# Errata Sheet

March 30, 2001 / Release 1.0

**Device:**     **SAB-C161O-LM**  
                  **SAF-C161O-LM**  
                  **SAB-C161O-LM3V**  
                  **SAF-C161O-LM3V**

**Stepping Code / Marking:**   **ES-HA, HA**

### 6. Timing of flag SSCTIR (SSC Transmit Interrupt Request)

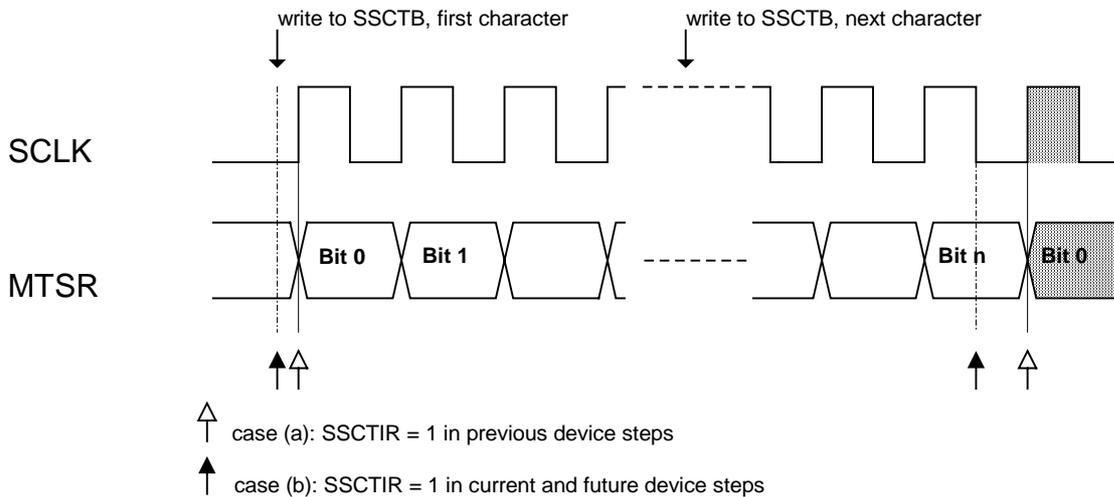
In master mode, the timing of SSCTIR depends on the device step as follows:

- (a) before step **FA** (internal stepping F11) of the **C161O**, flag SSCTIR is set to '1' synchronous to the shift clock SCLK 1/2 bit time before the first latching edge (= first shifting clock edge when SSCPH = 0). When SSCTB is written while the shift register is empty, the maximum delay between the time SSCTB has been written and flag SSCTIR=1 is up to 1/2 bit time.

(b) beginning with step **FA** (internal stepping F12) of the **C1610**, when SSCTB has been written while the transmit shift register was empty (and the SSC is enabled), flag SSCTIR is set to '1' directly after completion of the write operation, independent of the selected baud rate. When the transmit shift register is not empty when SSCTB was written, SSCTIR is set to '1' after the last latching edge of SCLK (= 1/2 bit time before the first shifting edge of the next character). See also e.g. C167CR User's Manual V3.1, p. 12-5.

The following diagram shows these relations in an example for a data transfer in master mode with SSCPO = 0 and SSCPH = 0. It is assumed that the transmit shift register is empty at the time the first character is written to SSCTB:

Typically, in interrupt driven systems, no problems are expected from the modified timing of flag SSCTIR. However, when flag SSCTIR is polled by software in combination with other flags which are set/cleared at the end or at the beginning of a transfer (e.g. SSCBSY), the modified timing may have an effect.

In order to achieve a defined and systematic behavior with all device steps, the SSC receive interrupt, which is generated at the end of a character transmission, may be used instead of the SSC transmit interrupt.
